DESIGN CHANGES

Drawing status FOR COMMENT

Project Name	County Flats, Sandfields
Project Ref	OAD_5174
Drawing Ref	1202
Drawing Name	Flat Type B01.1
Drawn By	WS

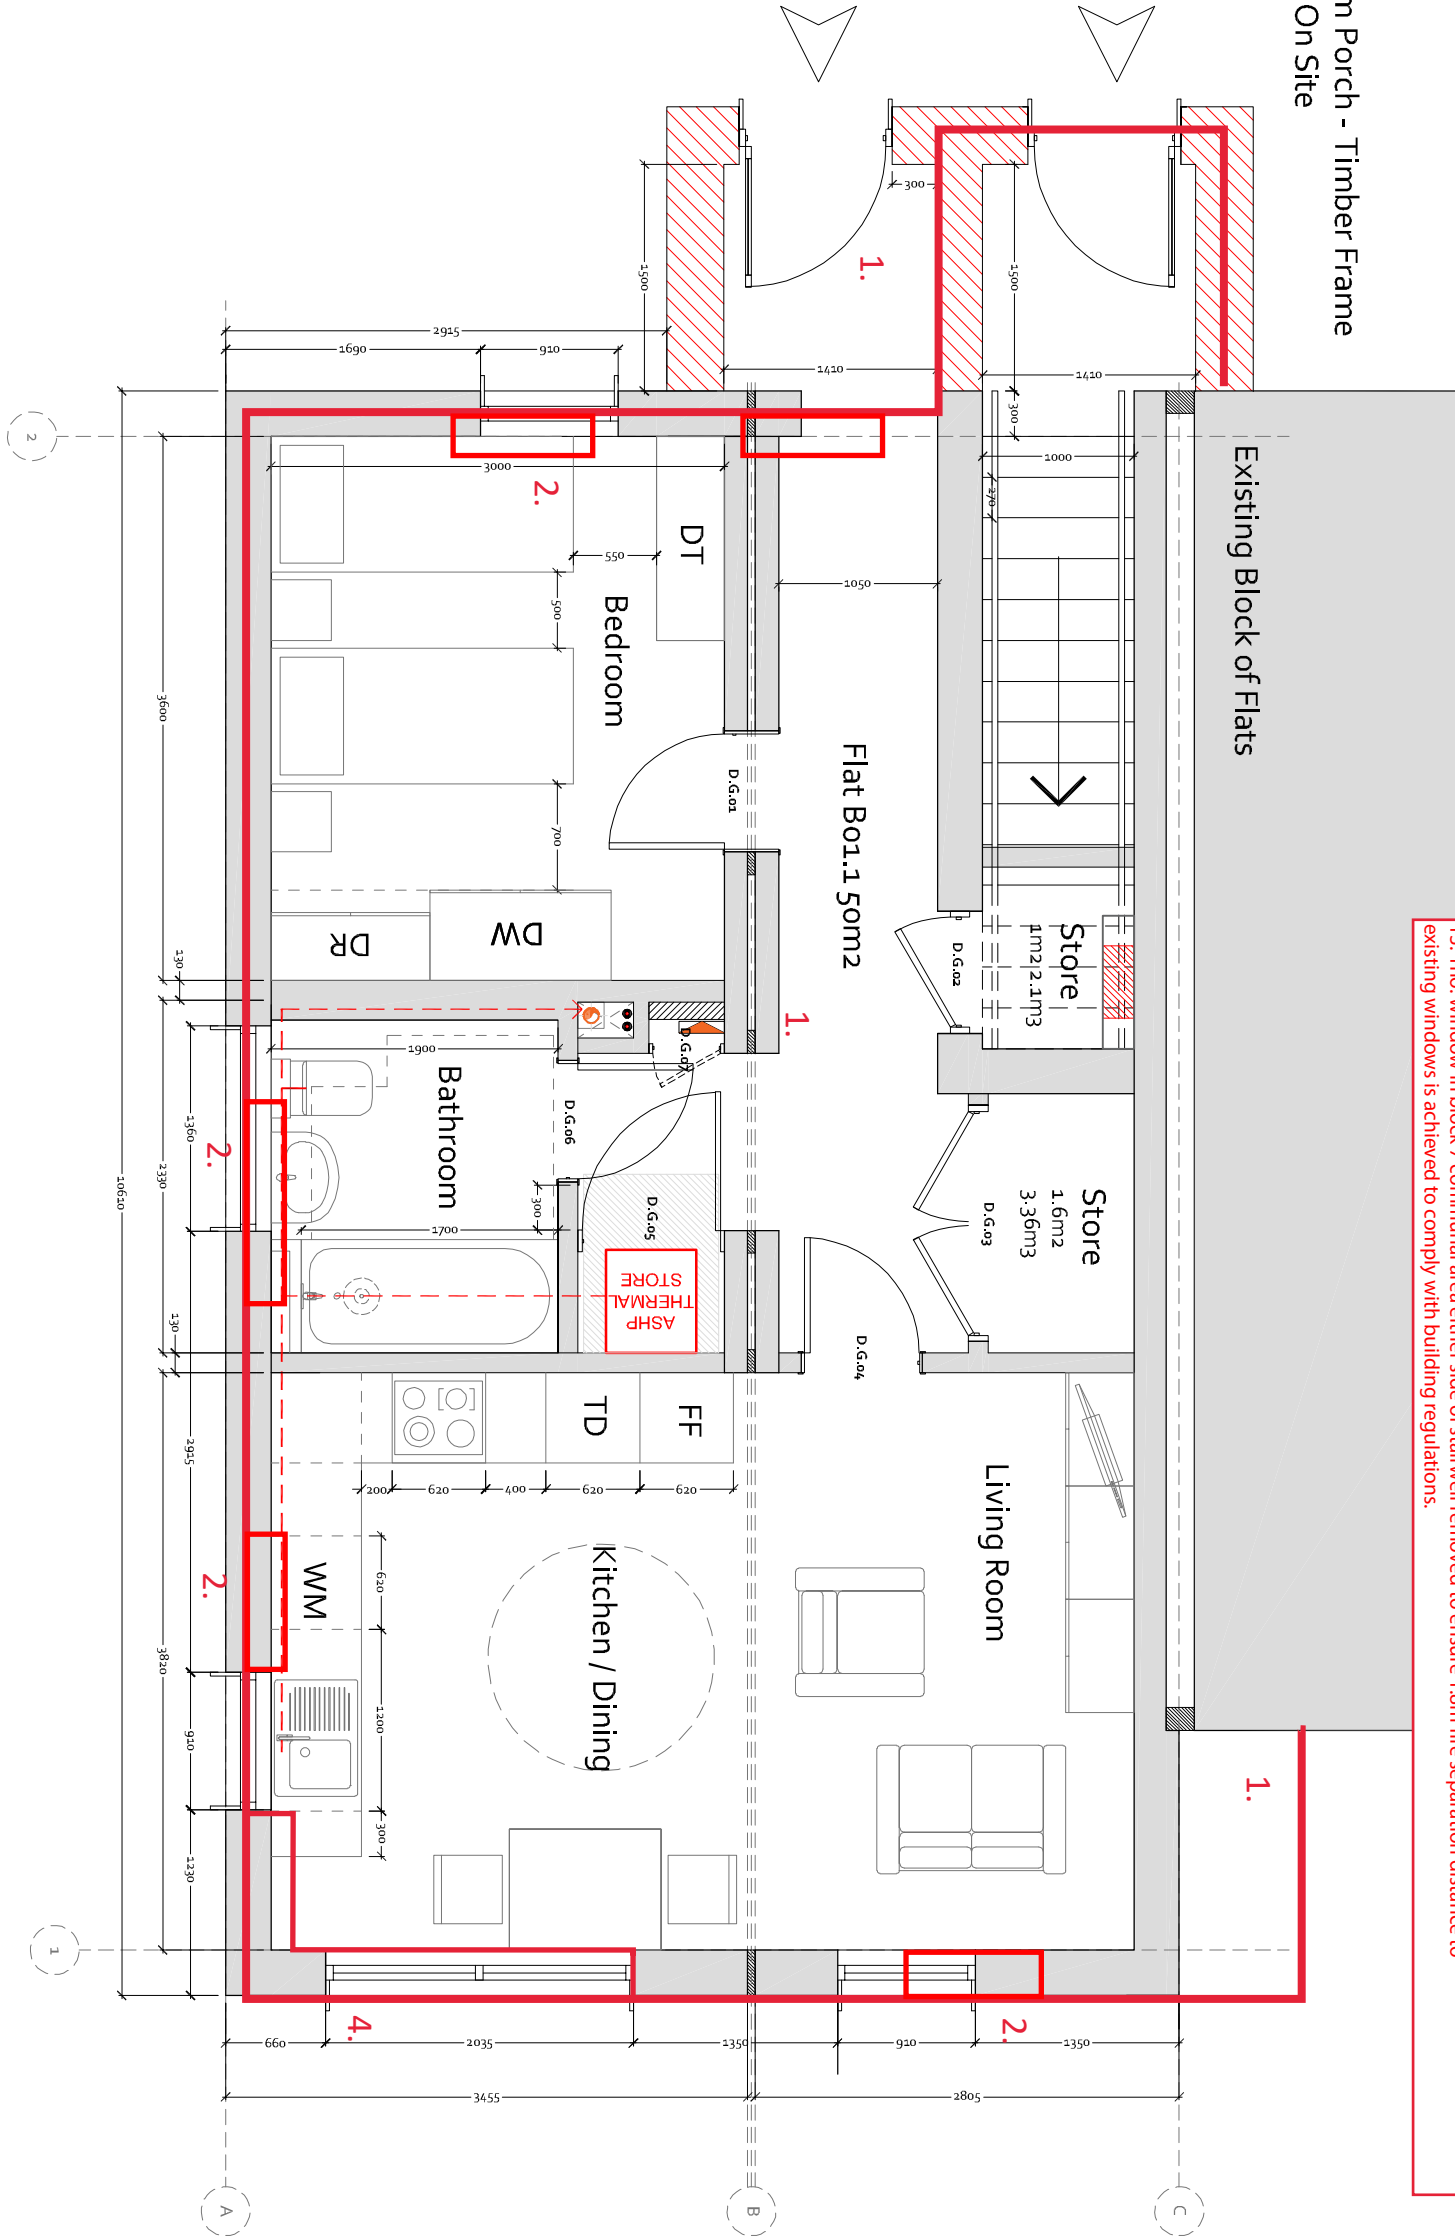
1. Modular end links re-positioned slightly off existing buildings, with the party wall straightened and porch projections aligned with this wall, to ensure modular construction can be achieved off site.
2. Windows have been slightly re-positioned to the new build to suit the structural design of the modular units and the constraints of the timber frame.
3. Parapet to modular end blocks have been lowered by approx 900mm to comply with the structural wind loadings and timber frame design.
4. Corner windows have been removed and replaced with 2no. Windows on either corner, again due to the structural and timber frame design of the blocks.
5. PV panels have been omitted from the end modular units to suit the structural and timber frame design of the blocks.

6. Ground floor Juliet balcony added to existing flats to provide better security whilst ensuring the open areas remain as communal spaces.
7. Air source heat pump external louvre enclosure amended to be single storey over entrance canopy to end link blocks.

8. External air source lowered enclosure handed to provide internal riser/access requirements for maintenance.
9. Buggy/cycle store added to block 6 and 7 parking courtyards.

10. Bin stores slightly re-positioned to suit existing drainage runs, with bin store near block 6 amended in size to suit located of bedroom window.
11. Footpaths amended to be Tarmac.

12. Windows in communal area to the linked blocks made narrower to ensure 1.8m fire separation distance to existing windows is achieved to comply with building regulations.

13. 1no. window in block 7 communal area either side of stairwell removed to ensure 1.8m fire separation distance to existing windows is achieved to comply with building regulations.

Front door has been pushed into an increased storm porch size to create the entrance for the ground floor flat. This was done to ensure modular construction can be achieved off site and to comply with DQR / Building Regulations.
